Access Compliance Report

Public Rights-of-Way

Intersection ID: 32245	Main Street: BALMORAL_PARK_DR	Cross Street: OXFORD_COMMONS_DR	Location: E
ADA ID: 62421451E7AE	Ramp Type: Perp	Initial Pass/Fail: Fail	Overall Compliance: No
Severity Score: 10			
Codes/Mitigation Info/Possible Solution		Field Measurements/Component Compliance

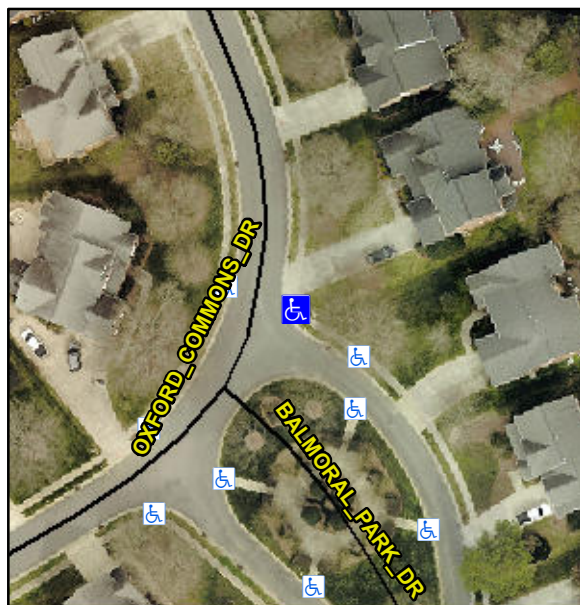
Not Found, R304.5.1

Compliance	Description	Data	Compliance	Description	Data
N/A	Ramp Length (in)	45.0	Yes	Ramp Slope (%)	5.9
No	Ramp Width (in)	38.0	Yes	Ramp XSlope (%)	3.4
N/A	Flare Type LT	N/A	N/A	Flare Type RT	N/A
N/A	Flare Slope LT (%)	N/A	N/A	Flare Slope RT (%)	N/A
N/A	Flare Traversable LT?	N/A	N/A	Flare Traversable RT?	N/A
N/A	Landing Length (in)	N/A	N/A	DWS Provided?	N/A
N/A	Landing Width (in)	N/A	N/A	DWS Contrast?	N/A
N/A	Landing Slope (%)	N/A	N/A	DWS Length (in)	N/A
N/A	Landing X Slope (%)	N/A	N/A	DWS Full Width?	N/A
N/A	Landing Curb? (Y/N)	N/A	N/A	DWS Offset (in)	N/A
N/A	Shared Landing?	N/A			
N/A	Gutter Ponding?	N/A	N/A	Gutter Slope (%)	N/A
N/A	Gutter Lip Ht (in)	N/A	N/A	Gutter X Slope (%)	N/A
N/A	Painted X Walk1?	No	N/A	Painted X Walk2?	N/A
	X Walk 1 Direction	To NW		X Walk 2 Direction	N/A
N/A	X Walk 1 Width (in)	N/A	N/A	X Walk 2 Width (in)	N/A
	X Walk 1 Slope (%)	2.4		X Walk 2 Slope (%)	N/A
	X Walk 1 X Slope (%)	3.7		X Walk 2 X Slope (%)	N/A

Remove & Replace Entire Ramp.
